TRANS/WP.29/708

World Forum for Harmonization of Vehicle Regulations (WP.29)

DRAFT SUPPLEMENT 5 TO THE 09 SERIES OF AMENDMENTS  
TO REGULATION No. 13

(Braking)

"3. Example of a simulator for electric control lines

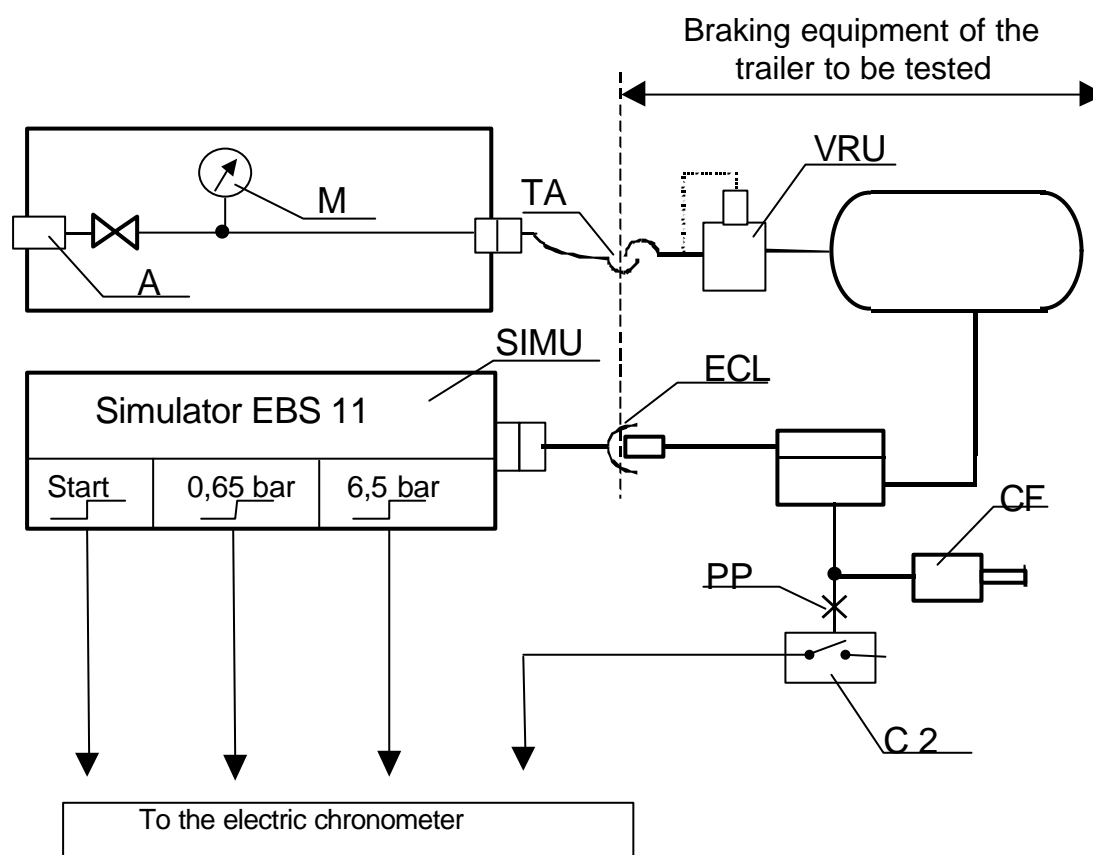
Annex 6, appendix, insert a new figure 3., to read:

ECL = electric control line corresponding to ISO 7638

SIMU = simulator of Byte 3,4 of EBS 11 according to ISO 11992 with output signals at start, 0.65 bar and 6.5 bar."
